FAQ 21-01: Unplanned Scrams with Complications for AP1000
Final Approved

Plant: Generic to AP1000 Reactors

Performance Indicator: IE04, Unplanned Scrams with Complications (USwC)

5. Conforming changes are needed in the depiction of PWR scram screening questions in Figure 2, as follows:

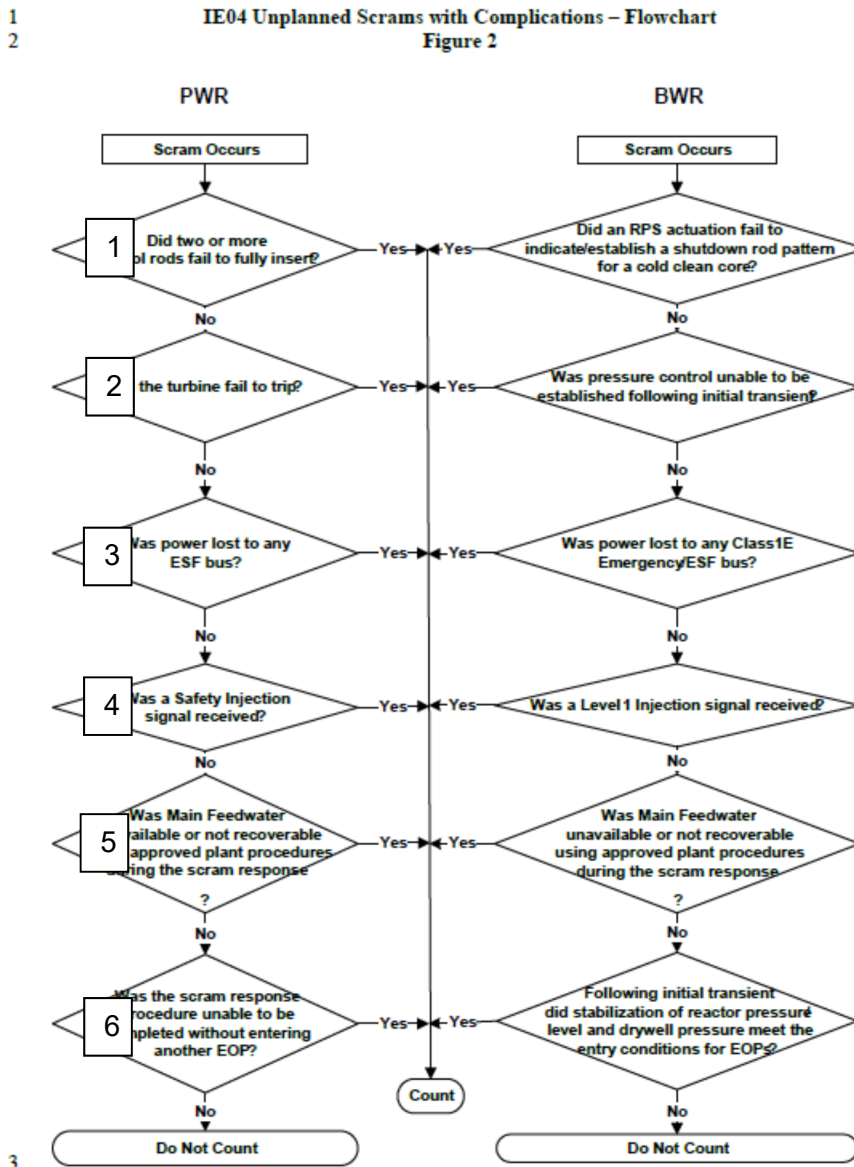
- a) For the third decision diamond, which reads, "Was power lost to any ESF bus?", add the following footnote: "For AP1000: Was power lost to any battery backed Class 1E DC and UPS System (IDS) bus?"
- b) For the fourth decision diamond, which reads "Was a Safety Injection signal received?", add the following footnote: "For AP1000: Was a Safeguards Actuation signal received?"
